NOTE: Drawing to be read in conjunction with CD151 003 Proposed Elevations

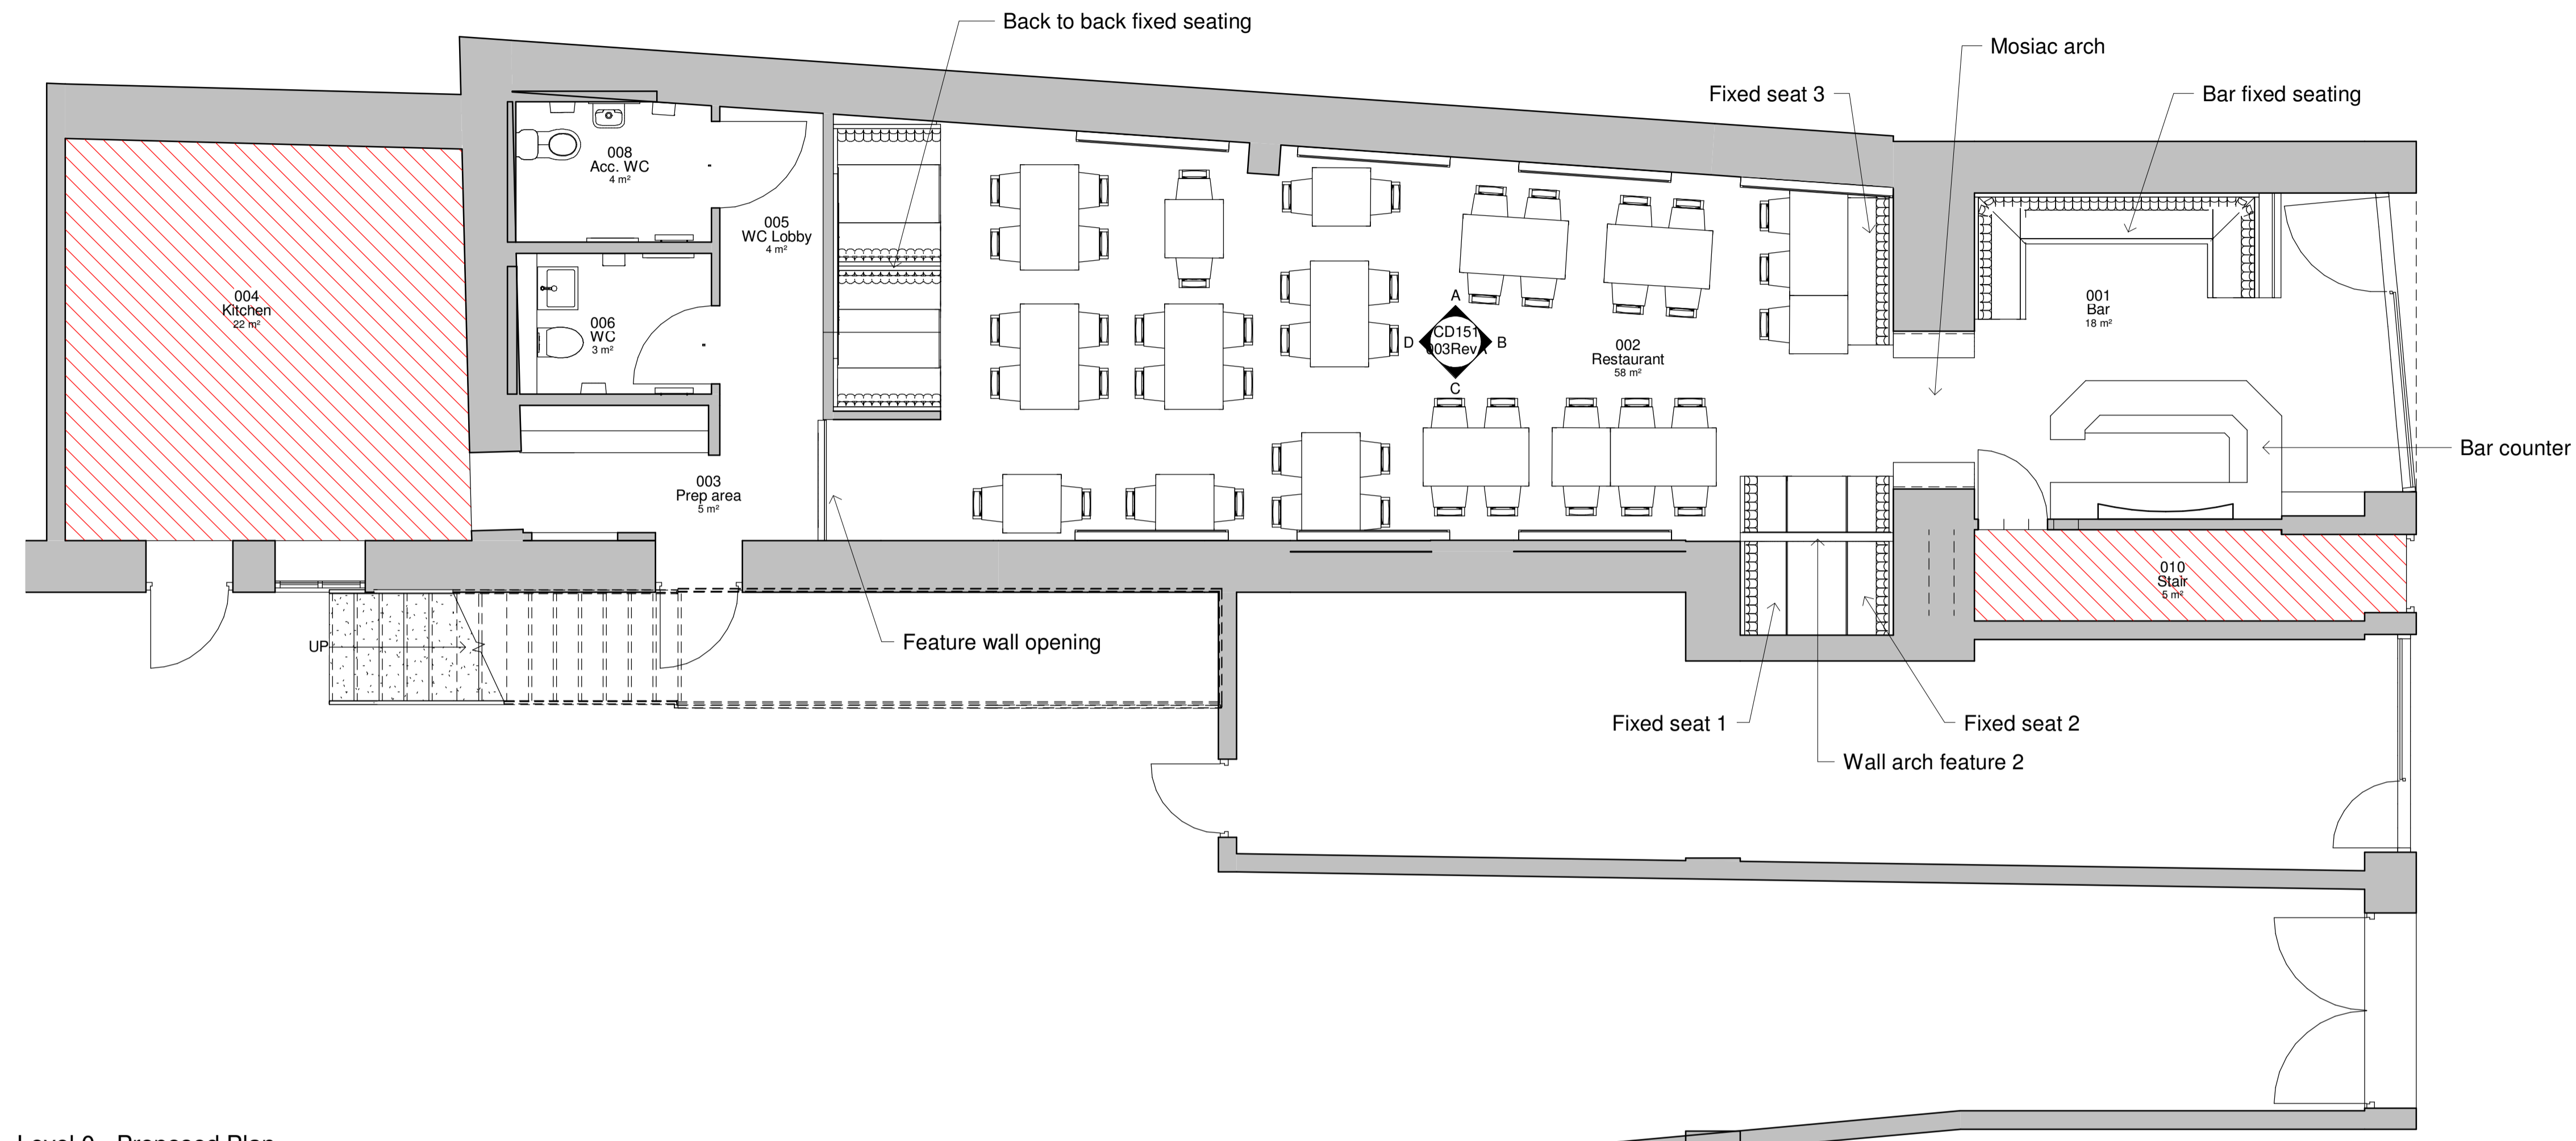
rev	by	chkd	date	amendments
G	JS	-	23.03.23	WCs re-configured to 1no. accessible WC and 1no. single WC.
F	JS	JS	22.10.19	Prep area updated in line with client comments on 01.10.19. Existing tall fridge to re-locate to external prep area. Prep area to include fixed worktop with storage under and solid surface shelving above.
E	JS	JS	29.04.19	WC layout updated in line with clients comments on 12.04.19. Acc. Male WC changed to Male WC with 1no. cubicle and 1no. urinal and sink.
D	JS	JS	27.03.19	WC layout re-configured to refine existing WC layout changing 2no. WCs to unisex. External extension omitted as per client meeting 05.03.19.
C	JS	NS	05.03.19	WC and restaurant configuration revised as per client meeting to retain WC area on ground floor and improving dining layout.
B	JS	NS	14.11.18	Male and Female WCs omitted and re-located to Level 01. Layout reconfigured.
A	NS	NS	18.08.16	Ramp indicated externally and internal amendments to space plan made following client meeting on 27.02.17.
